<b>Subject:</b> <b>SQUEAK NOISE FROM FRONT BRAKES AND/OR GROOVE MARKS ON FRONT DISC PLATE</b>	<b>Bulletin No:</b> 04-005/14
	<b>Last Issued:</b> 10/29/2014

2014-15 Mazda3

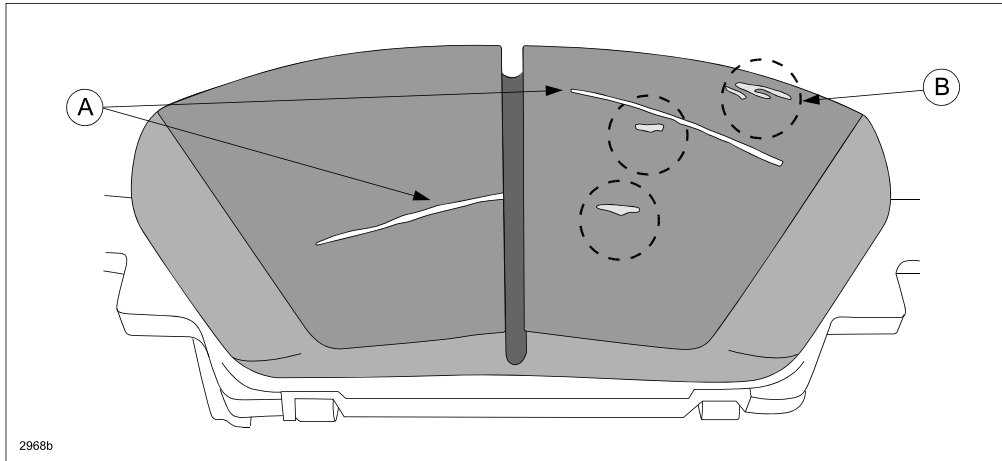
Visually inspect the front brake pads surface for pieces of metal.

- If metal pieces (silver or white in color) are found in a line (A) or cluster form (B) on the surface, replace the front brake pads with a modified service set.

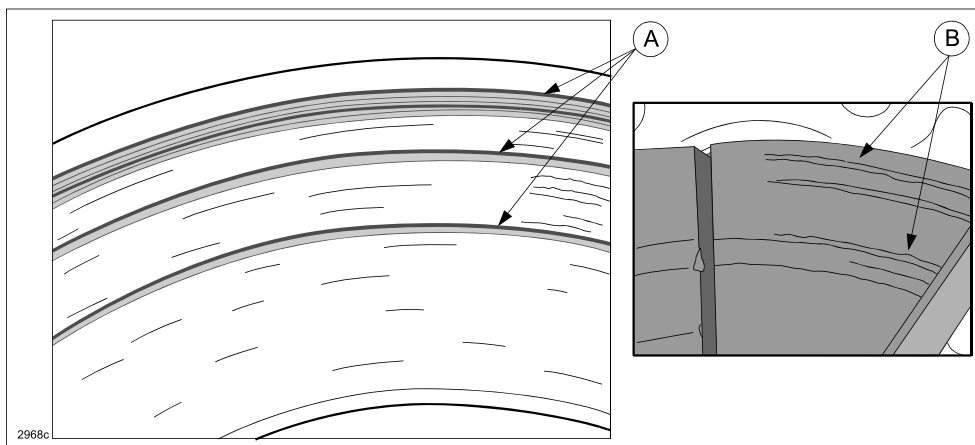
Visually inspect the surface of the disc plate(s) for damage.

- If groove damage is found on a disc plate (A) and brake pad (B), replace the front brake pads with a modified service set and ONLY the damaged disc plate(s).

**NOTE:** Metal may have dropped off the brake pad, and groove damage will be found on the brake pad in the same position as damage on the disc plate.
